UNITED STATES
NUCLEAR REGULATORY COMMISSION
WASHINGTON, D.C. 20555-0001

Comment on Draft Regulatory Guide DG-1145, Section C.I.2.5.2.4 Probabilistic Seismic Hazard Analysis and Controlling Earthquake and C.I.2 in General.

*Dr. Jens-Uwe Klügel,
NPP Goesgen-Daeniken, Switzerland*

Figure 1. Dependence of uniform duration on magnitude and distance for a fixed peak ground acceleration

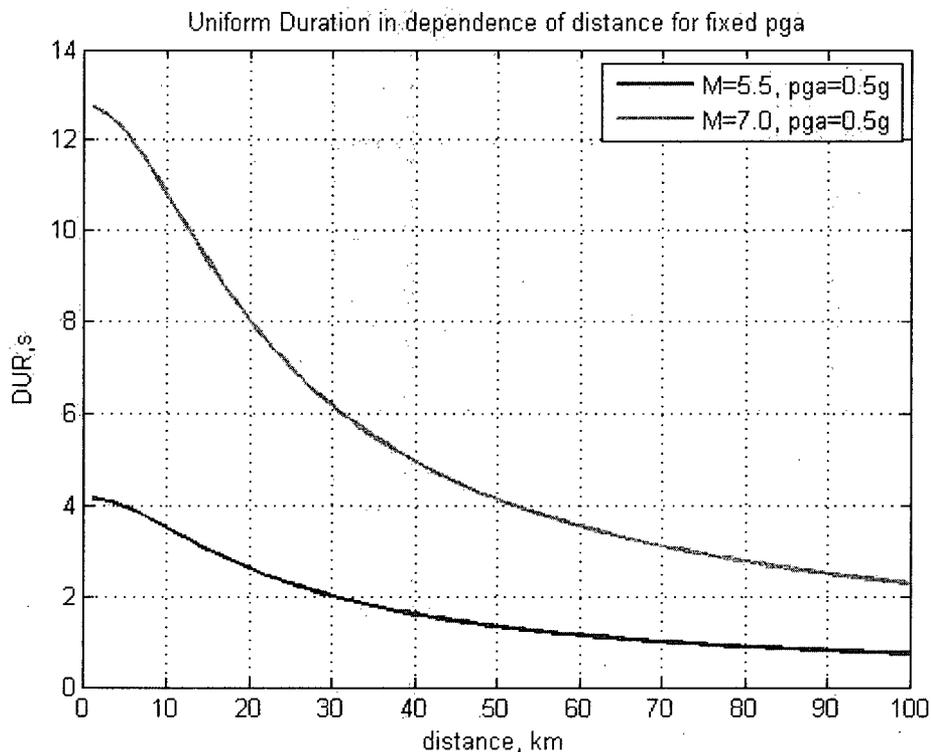
3. The model described in [1] is mainly based on a very specific PSHA model developed by Cornell [8] and McGuire [9]. The methodology described and supported in DG 1145 (as well as in NRC RG 1.165) potentially leads to a violation of energy conservation principles. The consequence is that the derived controlling earthquake(s) may be too optimistic with respect to their potential damaging impact. According to the procedures in [1], frequencies of earthquakes (from the same seismic source or from different seismic sources) resulting in the same ground motion at a specific site are added. The problem here is that this summation is performed despite the fact that these frequencies from different sources (or from the same source representing different magnitudes) correspond to different percentiles of the magnitude size distributions of the different sources and also to different energy levels. For example, an earthquake of magnitude 7 at a distance of 10 km to the site at a confidence level of -1σ can produce the same spectral acceleration as an earthquake of magnitude 5 at the same distance to the site at the confidence level $+1 \sigma$. The contributions to the hazard (to the corresponding spectral acceleration) are combined although the energy content and therefore the damaging potential of the two earthquakes are very different. This can be illustrated by the following figure 1 showing the uniform duration of earthquakes (as defined by Bolt, [10]) of different magnitudes resulting in the same value of peak ground acceleration ($\text{pga} = 0.5\text{g}$) at the site.

The correlation used for figure 1 was derived from a consistent data set of the WUS database [11] and published in [12]. It is obvious that the energy content and therefore very likely also the damaging impact of the different earthquakes are significantly different. Therefore, the Uniform Hazard Spectra (UHS) derived from PSHA represent an incoherent mixture of earthquake responses with respect to their energy content. Unfortunately, the frequency of occurrence of weaker earthquakes can be significantly higher than the frequency of stronger earthquakes. This has the consequence that the weaker (from perspective of energy content) earthquakes are preferably selected as controlling events by the usual deaggregation methods (based on accelerations). Indeed, this was observed in a simple sensitivity study [13]. Therefore, the design basis of new nuclear power plants derived by the proposed procedure can be too optimistic.
